Mask Set Errata 1 68H(R)C908JL3/JK3/JK1 8-Bit Microcontroller Unit

This mask set errata provides information pertaining to the glitch on timer buffered PWM output applicable to these 68H(R)C908JL3/JK3/JK1 MCU mask set devices:

2J88Y

The figure below shows a typical timer buffered PWM output waveform, indicating the TOF and OC events.

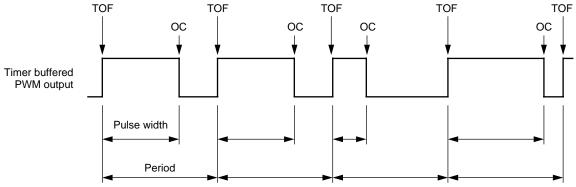
In timer buffered PWM operation, when a timer overflow (TOF) event or an output compare (OC) event coincides with a write to either pair of the timer channel registers (TCHxH/L), the duty cycle at the PWM output glitches to 0% or 100% momentarily, then returns to proper operation.

To avoid the glitches when changing the PWM duty cycle, do not write to either pair of the timer channel registers at the TOF or OC.

For example, in the TOF interrupt service routine: If the OC occurs near the last TOF, write to the timer channel registers after the OC; if the OC occurs near the next TOF, write to the timer channel registers before the OC. A write to the channel register high byte (TCHxH) should immediately followed by a write to the low byte (TCHxL) to avoid TOF or OC occurring between the writes. Instruction cycle times must be included when making timing calculations.

Do not write to either pair of timer channel registers at:

TOF (timer overflow), or

OC (timer output compare) edges.
